# UNITED STATES PATENT AND TRADEMARK OFFICE

APPLICATION NO.	FILING DATE	FIRST NAMED INVENTOR	ATTORNEY DOCKET NO.	CONFIRMATION NO.
10/565,469	01/19/2006	Tobias Melz	1033832-000013	9936
21839 7590 03/24/2008 BUCHANAN, INGERSOLL & ROONEY PC POST OFFICE BOX 1404 ALEXANDRIA, VA 22313-1404				
EXAMINER NGUYEN, XUAN LAN T				
ART UNIT 3683		PAPER NUMBER		
NOTIFICATION DATE 03/24/2008		DELIVERY MODE ELECTRONIC

### Office Action Summary

## **DETAILED ACTION**

### 第 3 図

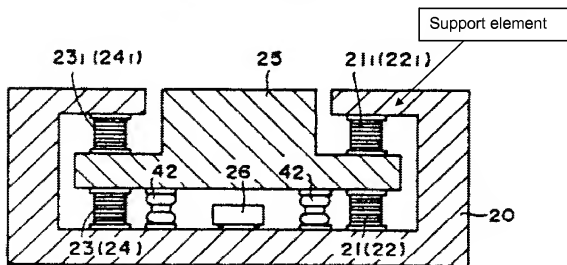
Re: claim 10, Katsumi shows an interface for reducing mechanical vibrations, as in the present invention, which has a base connection element 20, a load connection element 25 and at least one support element, as marked below, a) wherein at least a first energy converter system, 21, 23 bottom, extends between at least one engagement point located on the base connection element and at least one engagement point located on the load connection element; b) wherein at least one second energy converter system, 21, 23 top, extends between at least one engagement point located on the support element and at least one engagement point located on the load connection element; and d) wherein the load connection element 25 has a part located in an intermediate space between the base connection element and the support element, and a part located outside the intermediate space between the base connection element and the support element, as shown in figure 3. Katsumi lacks the elastic pipe surrounding the actuators as claimed. Sasaki shows an elastic pipe 14 for a vibration damper in figure 1 in order to provide further dampening capability to the

bearing body 13 at the same time to protect body 13 from environmental elements. It would have been obvious to one of ordinary skill in the art at the time the invention was made to have modified Katsumi's assembly to comprise an elastic pipe as taught by Sasaki in order to provide further dampening capability to the assembly of Katsumi at the same time protecting the assembly from environmental elements.
